Technical change to RSF LPK2, RSSD LPK2 and RS VERT LPK2 modules

PCN-number: 20240508

Example of Family RS SD (w/ LPK connector)

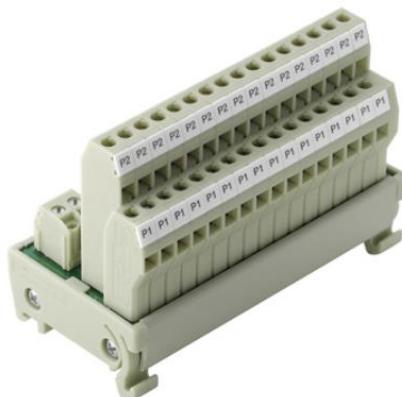
Articles on Section 5 were delivered in the past with LPK connectors. Furthermore, they were delivered with Dekafix*

*Dekafix is the universal marker for terminals, plug-in connectors and electronic modules from the Weidmüller product range (see detail).

2. Technical change

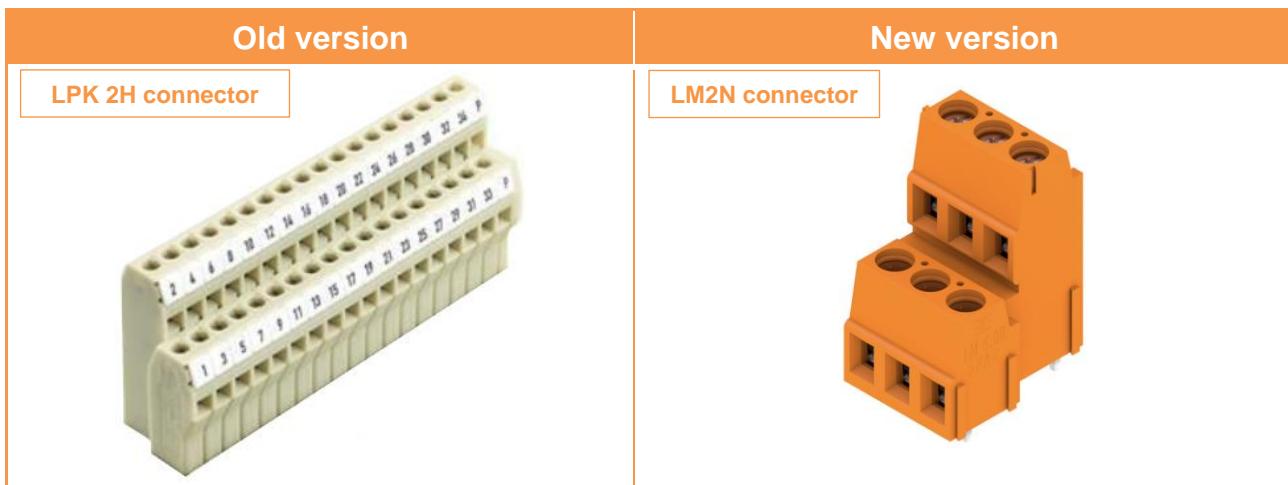
Based on continuous improvement the LPK connectors will be replaced by LM2N connectors with Tampoprint.

Obsolescence of LPK connector range.

Current modules in stock may have old components. As soon as LPK connectors are finished, new productions will be done with the new modifications detailed above.
